Re: Final Environmental Impact Statement (EIS)
Kaloi Gulch Drainageway Improvements at Oneula Beach Park
Tax Map Keys 9-1-11: portion 7 and 9-1-12: portion 25

ACCEPTANCE REPORT

KALOI GULCH DRAINAGEWAY IMPROVEMENTS
AT ONEULA BEACH PARK
FINAL ENVIRONMENTAL IMPACT STATEMENT (EIS)
TAX MAP KEY 9-1-12: PORTION 25 AND 9-1-11: PORTION 7

FIGURE 6-1
ONEULA ARCHAEOLOGICAL DISTRICT
Kaloi Gulch Drainageway
Improvements at Oneula Beach Park
HASEKO (Ewa), Inc., Ewa, Oahu, Hawaii

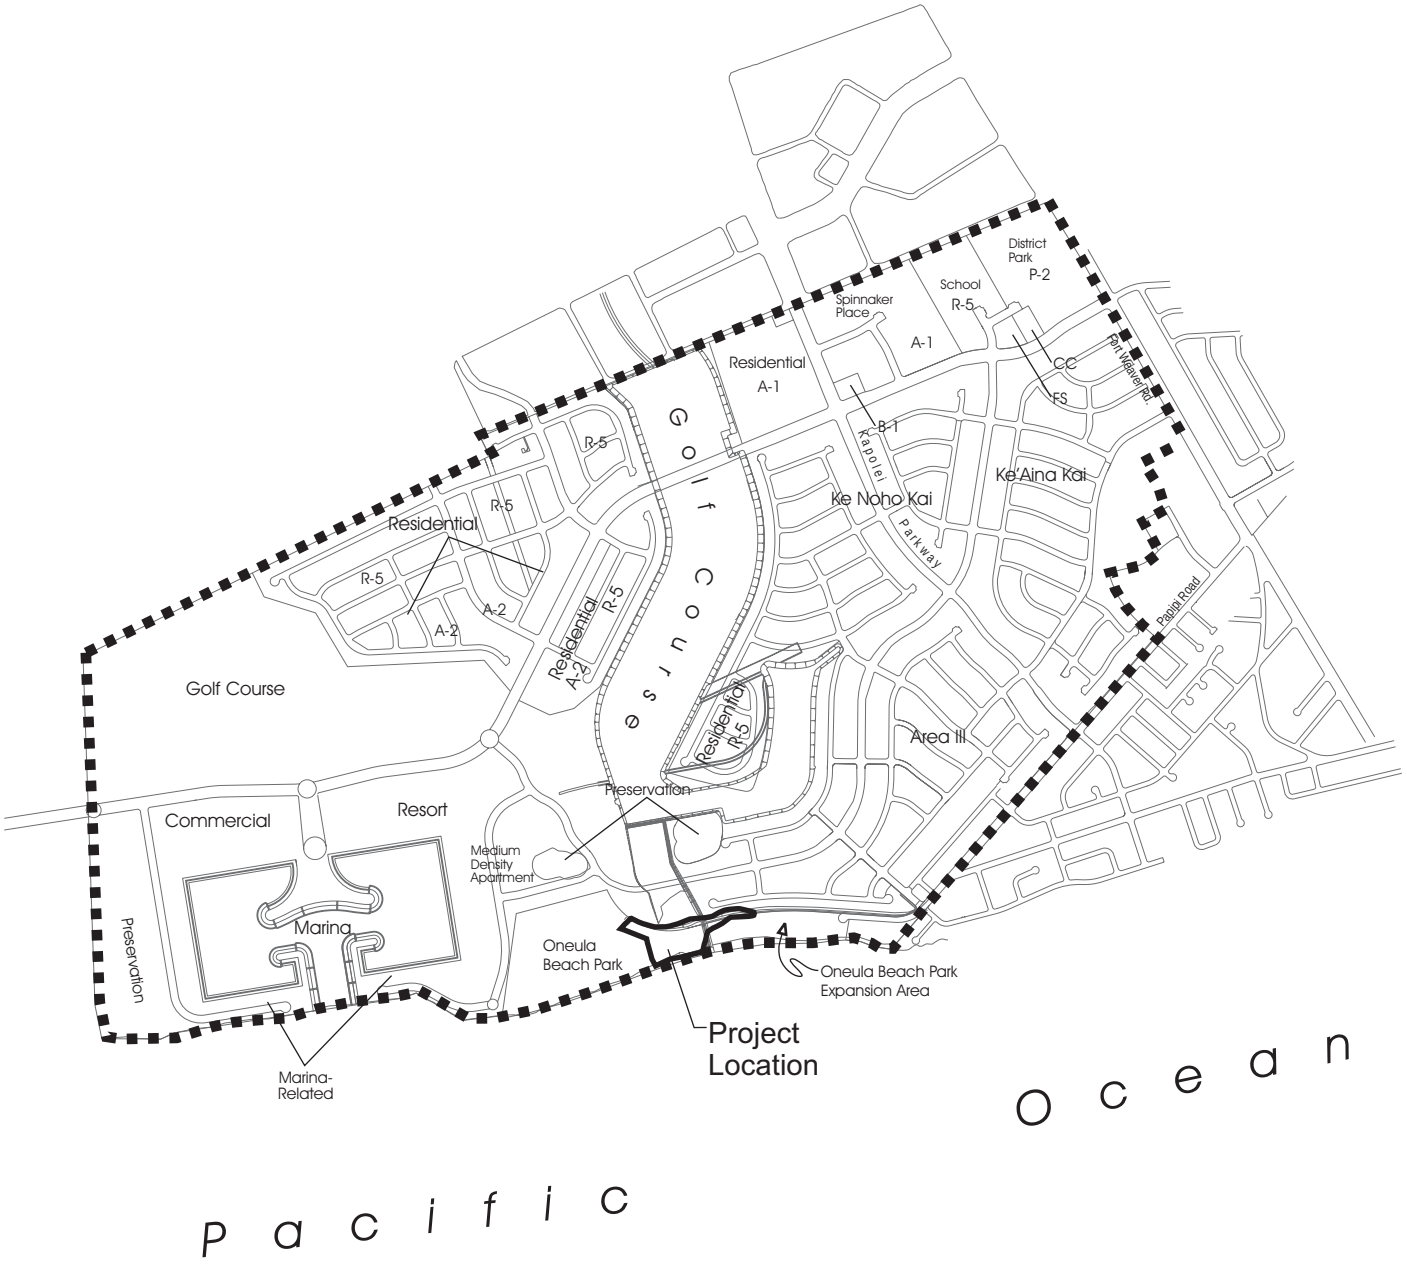
7. On Page 52, Figure 6-1, Oneula Archaeological District, shows a "Papipi Drive". This should be "Papipi Road".

7. *On page 52, Figure 6-1, Oneula Archaeological District, show a "Papipi Drive." This should be "Papipi Road."*

Page 6-5, Figure 6-1 and Page 6-7, Figure 6-2: These figures differ somewhat from the "Proposed Master Plan for Ocean Pointe", dated March 17, 2004, copy attached. Specifically, the March 2004 Master Plan shows the extension of Kaileolea Drive across a portion of the golf course to the A-2 zoned Marina area, and north to connect to Keoneula Boulevard. Haseko incorporated this connection in response to our December 3, 2003 comments on an earlier draft Ocean Pointe Master Plan. For consistency, the updated March 2004 Ocean Point Master Plan should be utilized as a base layer for both Figures 6-1 and 6-2.

Page 6-5, Figure 6-1 and Page 6-7, Figure 6-2: These figures differ somewhat from the "Proposed Master Plan for Ocean Pointe", dated March 17, 2004, copy attached. Specifically, the March 2004 Master Plan shows the extension of Kaileolea Drive across a portion of the golf course to the A-2 zoned Marina area, and north to connect to Keoneula Boulevard. Haseko incorporated this connection in response to our December 3, 2003 comments on an earlier draft Ocean Pointe Master Plan. For consistency, the updated March 2004 Ocean Point Master Plan should be utilized as a base layer for both Figures 6-1 and 6-2.

Response: Thank you, we acknowledge this point of clarification. We have used the updated March 2004 Ocean Pointe Master Plan as a base layer for a revision to Figure 6-1, Ocean Pointe Master Plan and Figure 6-2, Oneula Archaeological District.
